Service Bulletin

Bulletin No: 2010-1-08

Subject: Upper Rear A-Arm Axle

Affected Models: All 2010 500 Sno Pro (2010 600 Sno Pro*)

Fig. 1

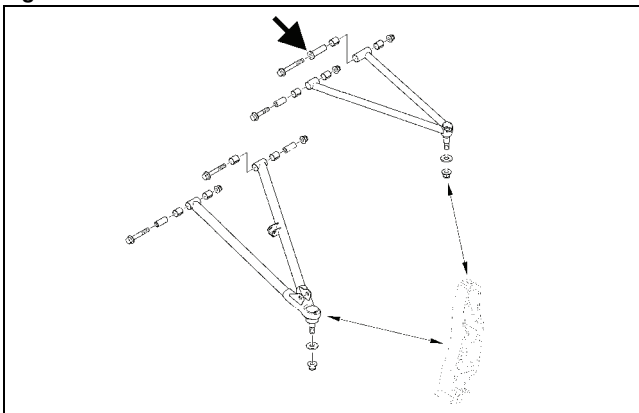
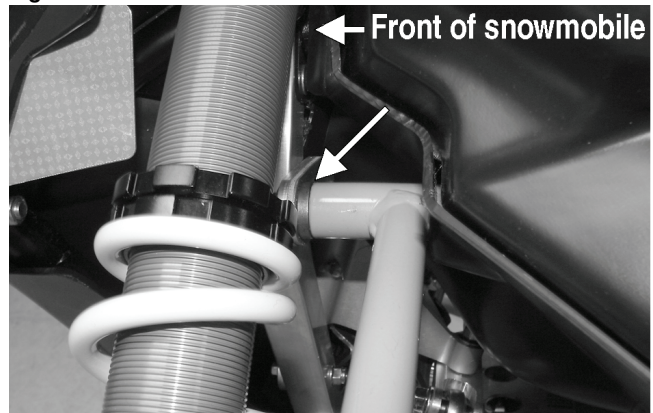
Condition: On the affected models, the upper rear A-arm axle was installed in the upper A-arm from the rear which is **incorrect**.

2. Remove the upper rear axle from the upper A-arm and install from the front. See Fig. 1 and 2.

Solution: Remove the upper rear A-arm axle from the upper A-arm; then install A-arm axle from the front according to the instructions below.

3. Secure the upper A-arm to the chassis using existing cap screws and lock nuts; then repeat for opposite side. Tighten to 40 ft-lb.

III. 1

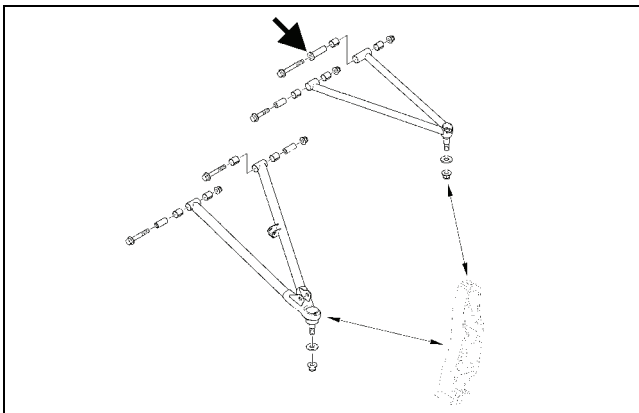
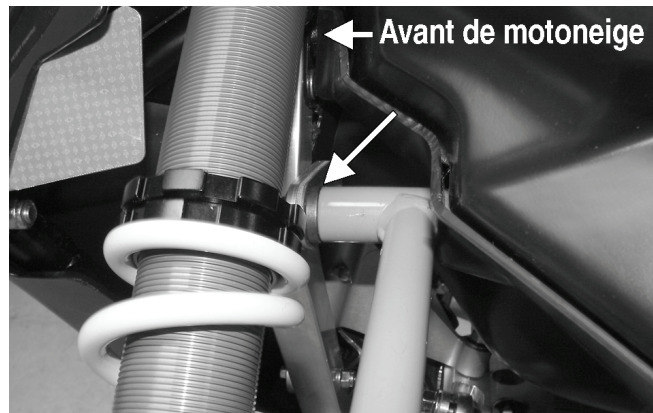
Condition: Sur les modèles concernés, l'axe de bras en « A » arrière supérieur a été installé sur le bras en « A » supérieur en partant de l'arrière, ce qui est incorrect.

1. En ayant d'abord élevé le devant de la motoneige, retirez les écrous de blocage et les vis à capuchon du côté gauche fixant le bras en « A » au châssis.
2. Retirez l'axe arrière supérieur du bras en « A » supérieur et installez-le en partant de l'avant. Consultez l'III. 1 et 2.

Solution: Retirer l'axe de bras en « A » arrière supérieur du bras en « A » supérieur; installer ensuite l'axe de bras en « A » en partant de l'avant conformément aux instructions ci-dessous.

3. Fixez le bras en « A » supérieur au châssis à l'aide des vis à capuchon et des écrous de blocage retirés au début; répétez du côté opposé. Serrez à un couple de 40 lb-pi.
